Date: March 21, 2019
To: Planning Board
From: Lincoln Daley, Community Development Director
Subject: SD2019-01 - Richard Keogh, Tax Map 23, Lot 2, 118 Amherst Street. Major Subdivision Plan – Design Review proposal to subdivide the subject parcel into nine (9) total lots, the construction of an 820’ linear foot subdivision roadway, and related drainage/stormwater improvements.

**Re: Interdepartmental Review Map 23 Lot 2
Major Subdivision - Keogh**

DESIGN REVIEW SUBDIVISION PLAN
LAND OF:
RICHARD N. KEOGH
TAX MAP 23 LOT 2
MILFORD, NEW HAMPSHIRE
SCALE: 1" = 60' FEBRUARY 25, 2019

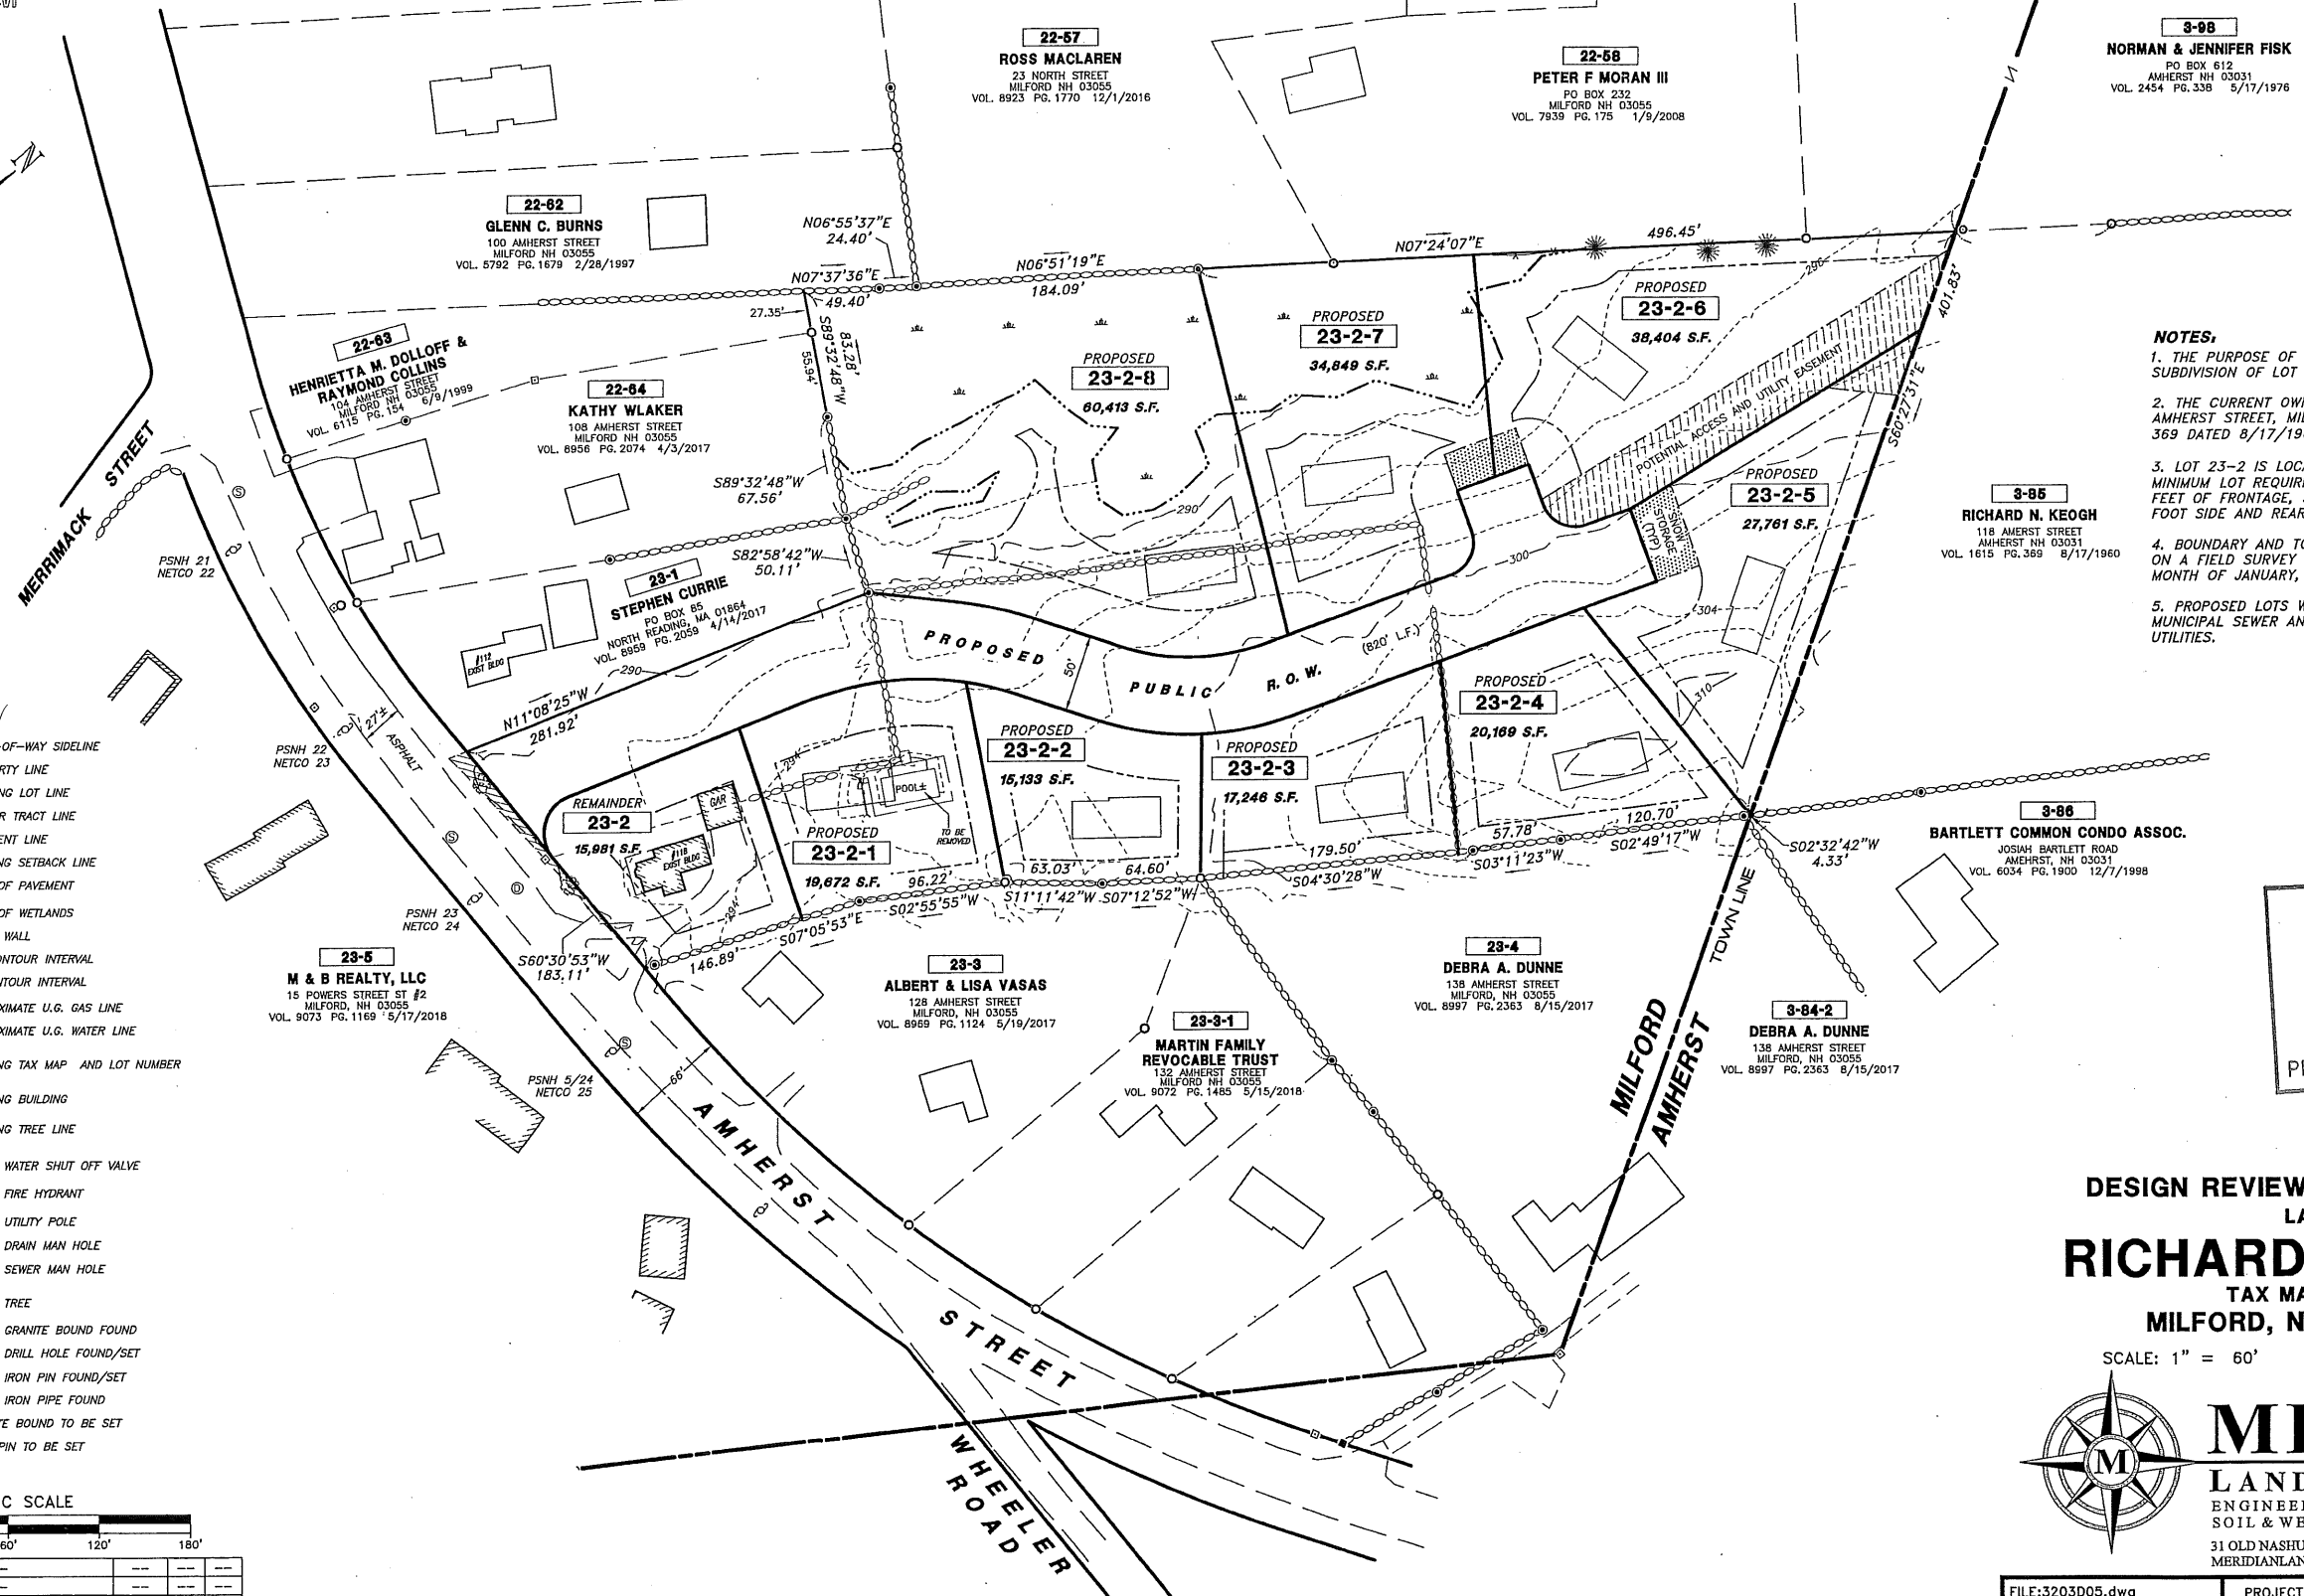
Based on the design and layout, the applicant is proposing a 9 lot conventional subdivision design. As stated previously, each of the proposed lots meet the minimum 15,000 square feet and 100 linear feet of frontage. Staff questions the viability of Map 23, Lot 2-8 given the limited building envelope due the extent of the delineated wetland resources areas and location of a detention basin within what appears to be feet from the residential house. The applicant should discuss and further clarify how this lot satisfies the purpose and intent of development regulations by providing

In addition, the accessory structure shown on Map 23, Lot 2-2 associated with the existing house, appears to encroach upon the 30 foot front setback (new subdivision road) and 15 foot side setback and thus would require a Special Exception. The density is based on the number of lots which could be laid out in a conventional subdivision without the need to obtain variances, special exceptions, and/or waivers for lot frontage, setbacks, area, road and driveway grades. The applicant should clarify or consider revising the plan.

The stormwater management design has not been submitted as part this application. The plan displays a detention basin on southern side of the proposed Map 23, Lot 2-8.

1. The plans display several existing stone walls on the property. The applicant is encouraged to reuse and incorporate the stone into the subdivision design and layout.

2. The snow storage areas shown at the ends of the subdivision roadway turnaround are located outside of the proposed Right of Way and would require the access/maintenance easements to store and maintain snow on private property.

3. Driveways located off of the ends of the turnaround areas of the proposed roadway are strongly discouraged (see lots 23-2-6 and 23-2-5).
4. The applicant should explain the purpose and intent of the proposed “potential access and utility easement”.

5. Please provide the total buildable enveloped for Map 23, Lot 2-8 subtracting the wetland resource areas, buffers, and the detention basin.
6. The existing sidewalk network is located 230 linear feet from the entrance of the proposed subdivision. Pursuant to
